# **DRAINAGE LETTER REPORT**

## **INTELIFAB LOT 1, MAYBERRY, COLORADO SPRINGS FILING NO. 2**

**PCD File no. PPR2012**

**C1.1**

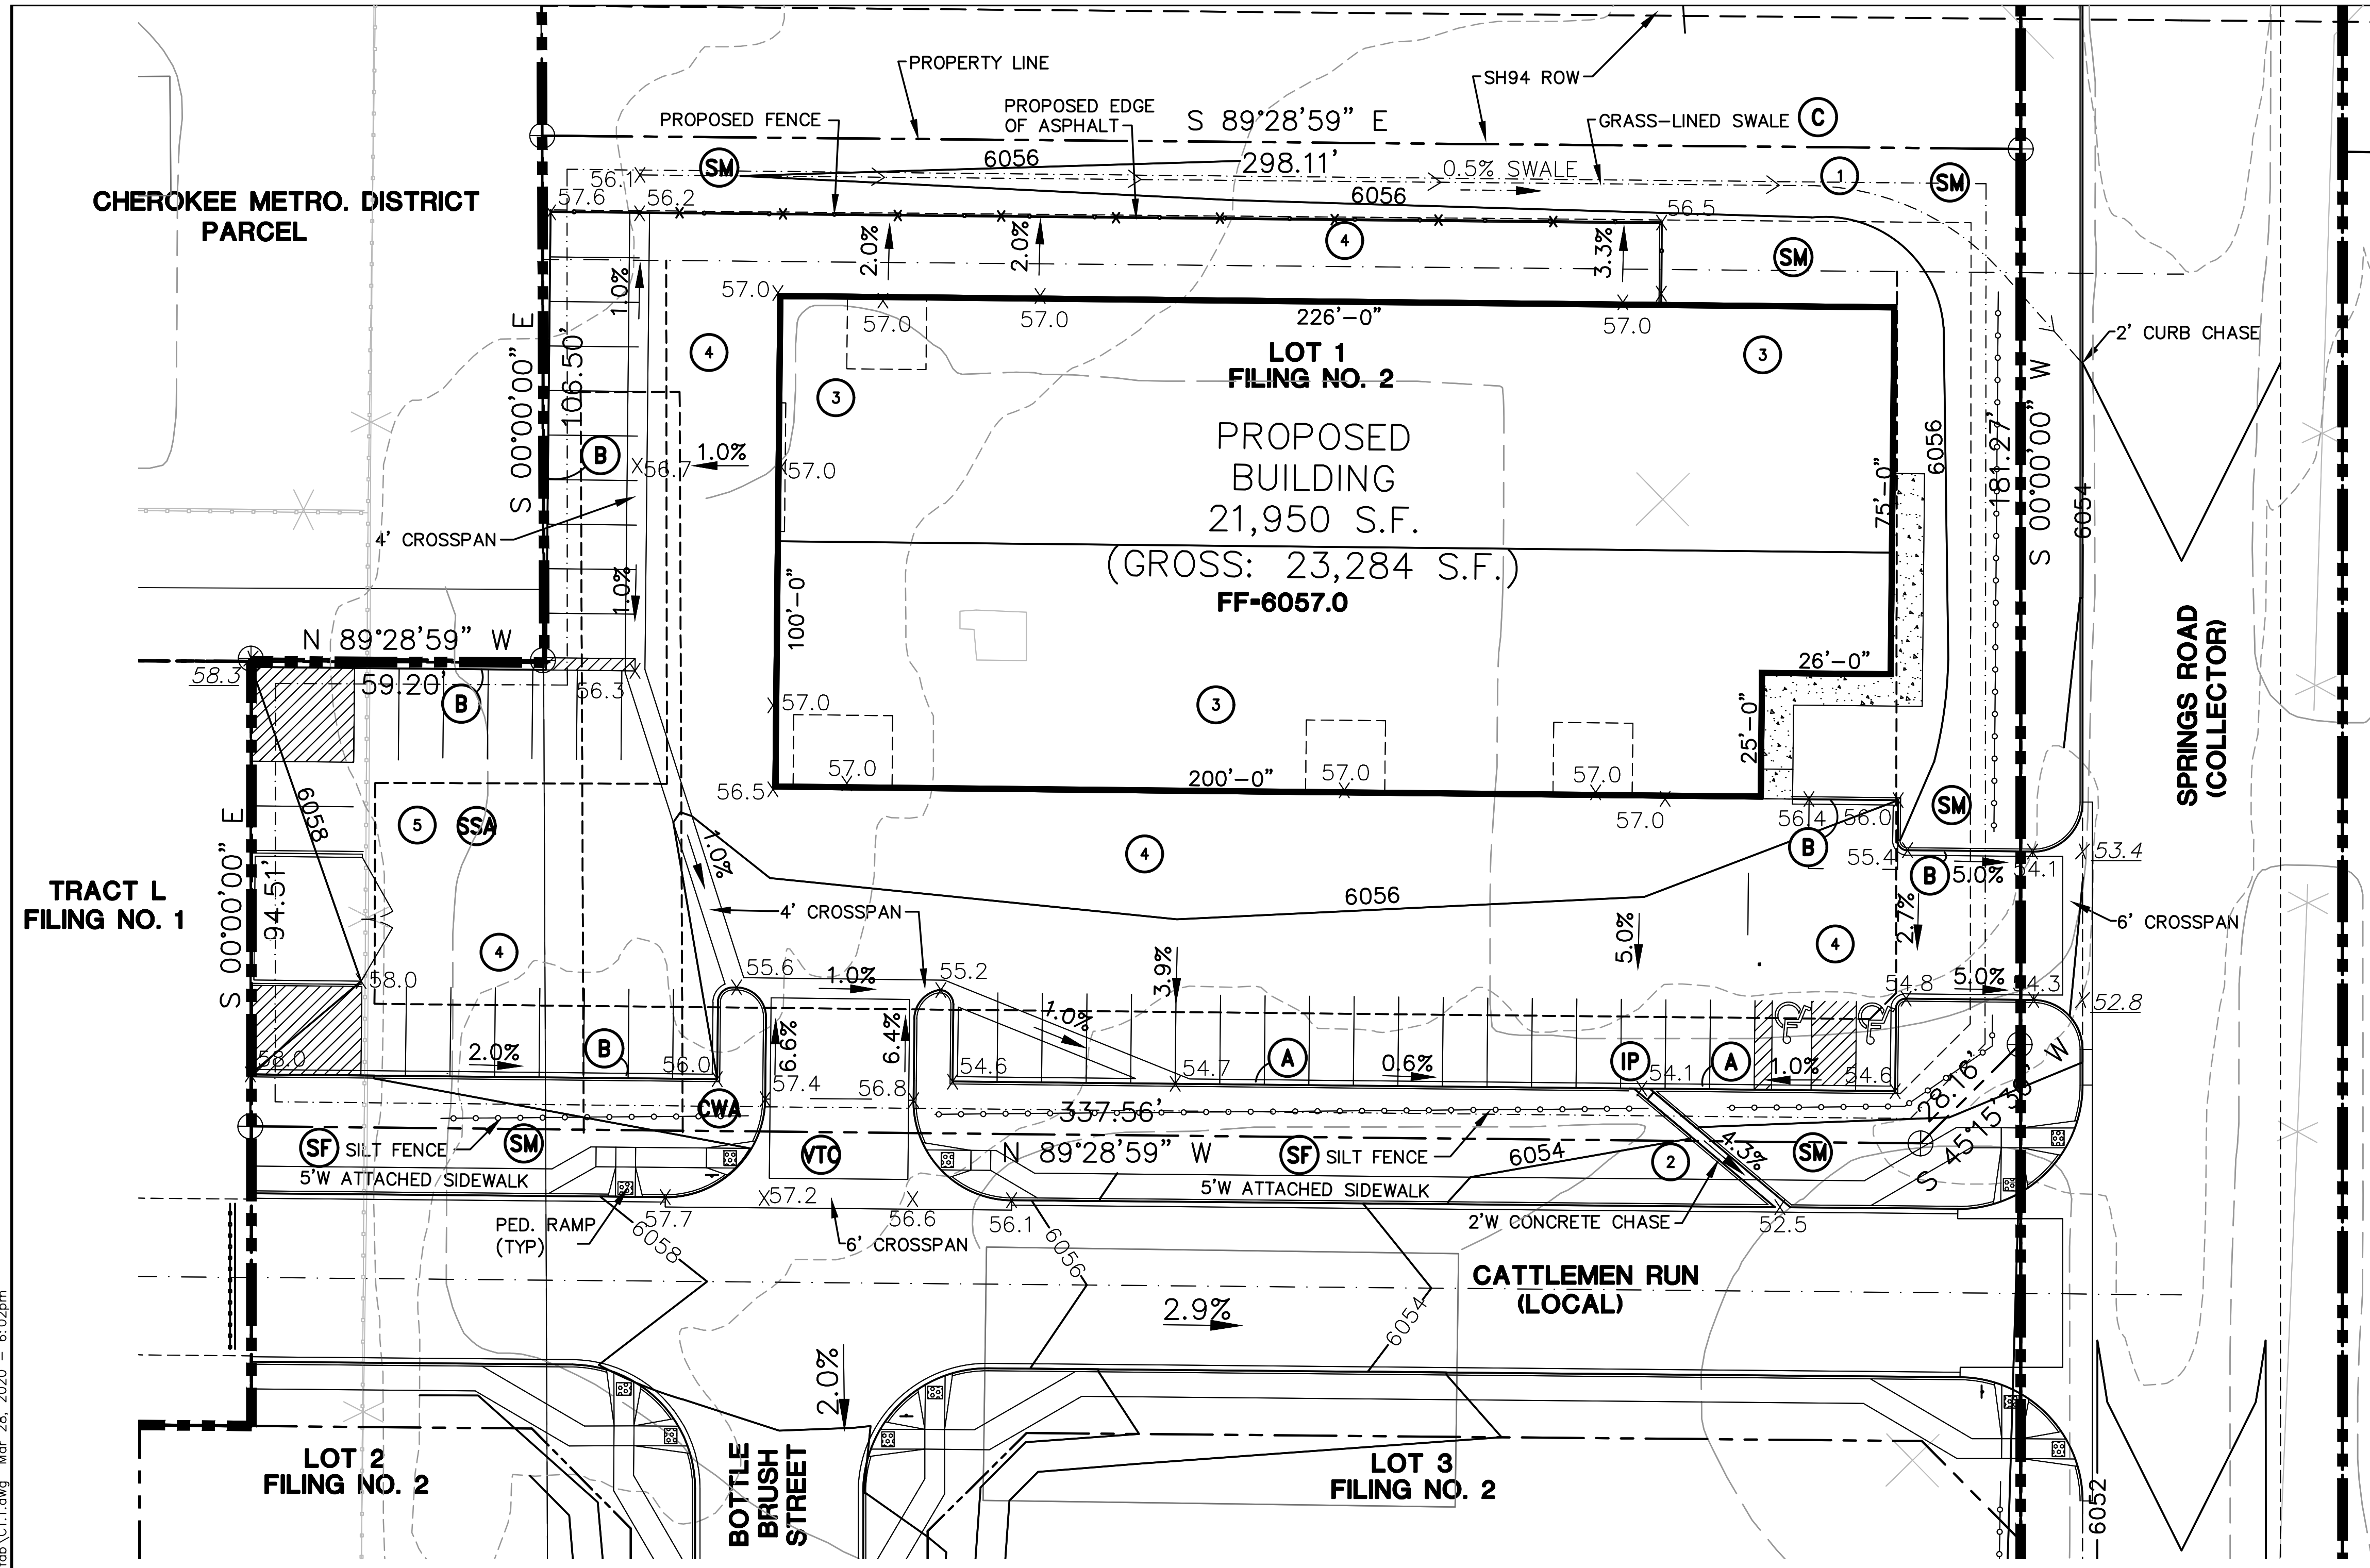
Please also include discussion of the crosspans to be installed in the parking areas.

Provide a design calculation for the proposed grass lined drainage swale.
